Canon Comments on Energy Star Imaging Equipment Final Draft

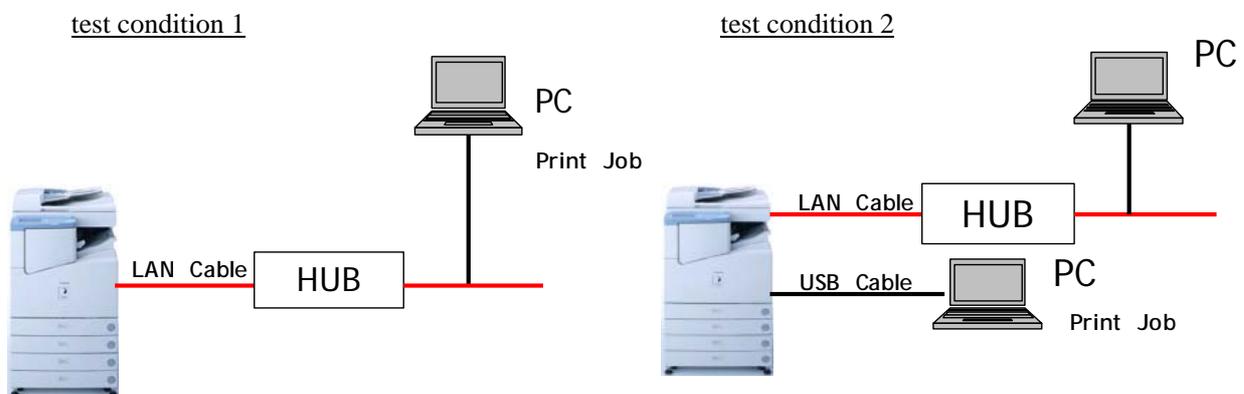
We would like to propose again two postscripts as the test parameters for products capable of network connection as below:

1. At least one PC shall be connected on a network; and
2. When print jobs for the test are transmitted from a network connection, all the setting of printing of the PC shall be a set of default conditions..

In short, in the test, products capable of being networked must connect network including more than one PC and PC setting must be default one. (Those are the test conditions that we would like to add to at this time.) But print jobs may sent through non-network connections like USB as before.

The figure of test conditions which we consider as appropriate may be one of the two compositions below :

The reason why we propose the postscripts, for example, as follows: sometimes resulted TEC value largely may differ from the condition whether the network connected to the product includes a PC or not, when the print jobs are sent via a non-network connection (USB). In addition, there are also the cases where differences in TEC values are caused by setting of the connected PC. If there are not two postscripts as claimed in the above, TEC values might vary because of the variation of test conditions which every producer set, and therefore, it becomes difficult to compare TEC values closely.
